Master File #: S-2017-002

Incompleteness Response:

PRELIMINARY SUBDIVISION PLANS FOR KEIL GARDENS SUBDIVISION

SHEET TITLE:
 PRE-PLAT
 C-1.09

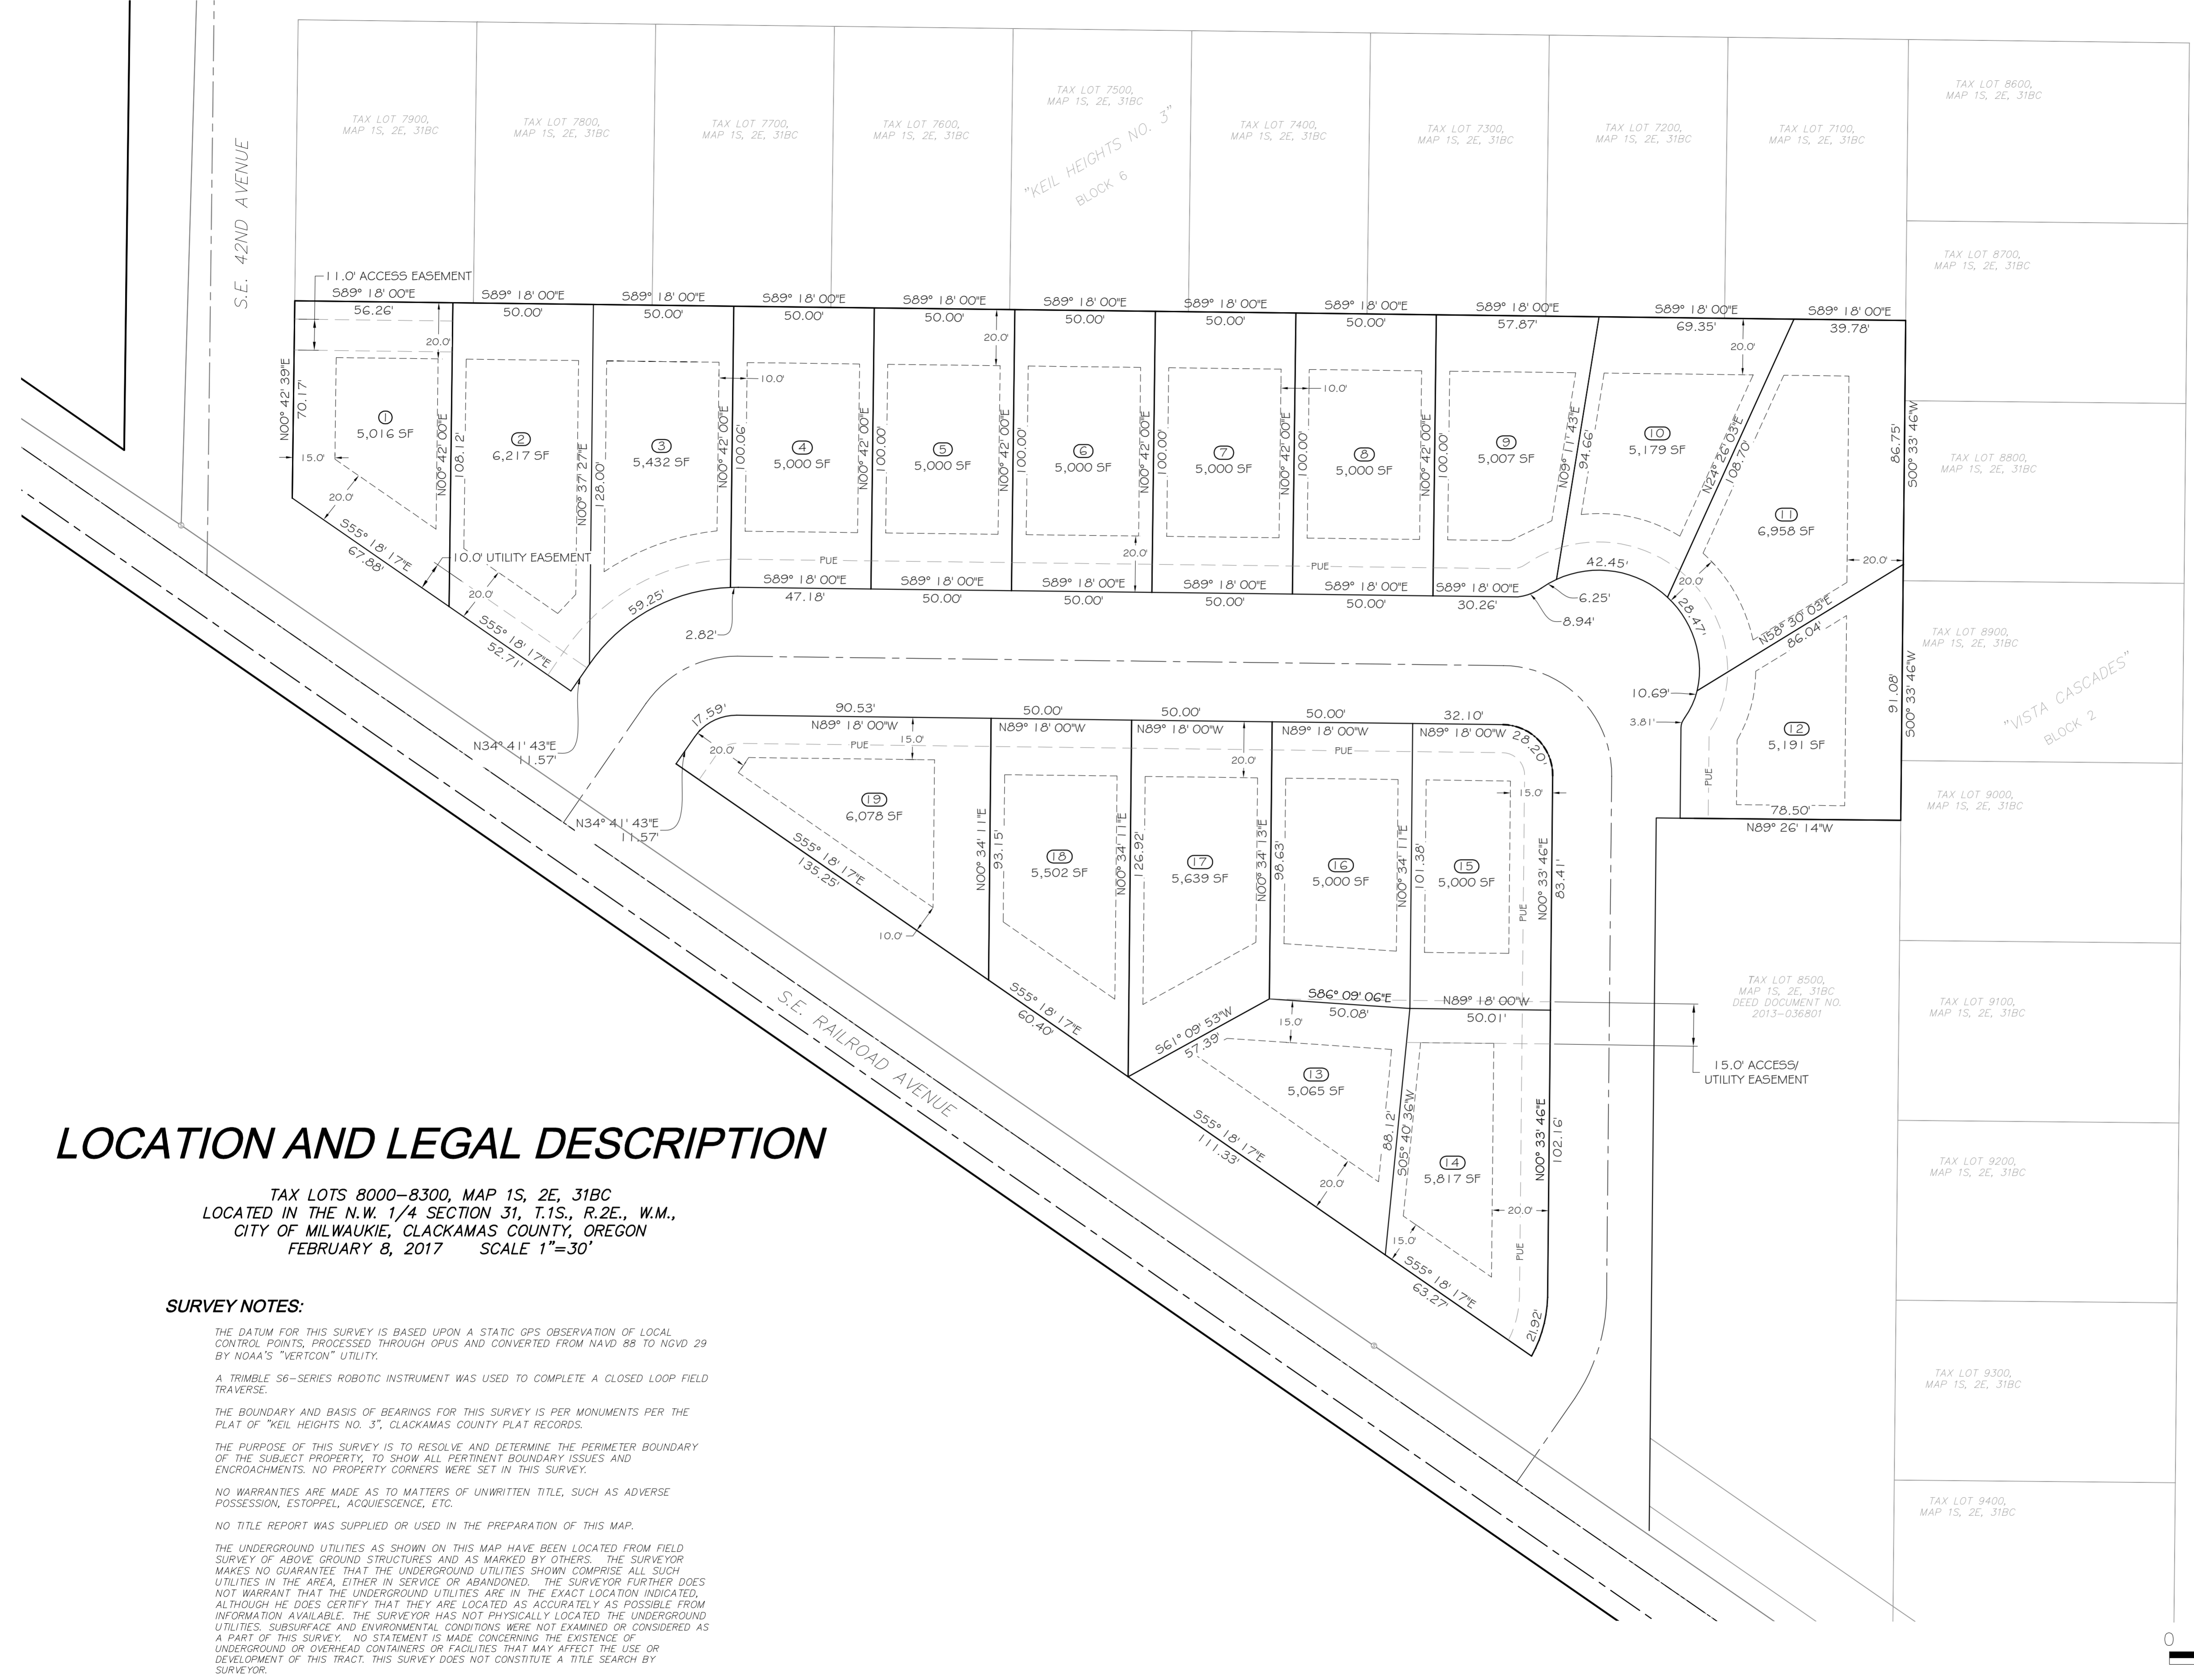
- b. The preliminary plat as submitted (Sheet C-1.09) has not been stamped by an Oregon registered land surveyor as required.

c. The preliminary plat as submitted (Sheet C-1.09) does not include the location by section, township, and range and does not include a legal description as required.

d. The preliminary plat as submitted (Sheet C-1.09) does not include the name and address of the person who prepared the plans as required.

Comment: The Preliminary Plat Plan has been updated to reflect that it has been prepared by and ORLS.

Comment: Preliminary Plat has been revised to include location by section, township, range, and legal descriptions describing said property.

Comment: Preliminary Plat has been revised to include the name and address by whom have prepared (Centerline Concepts).
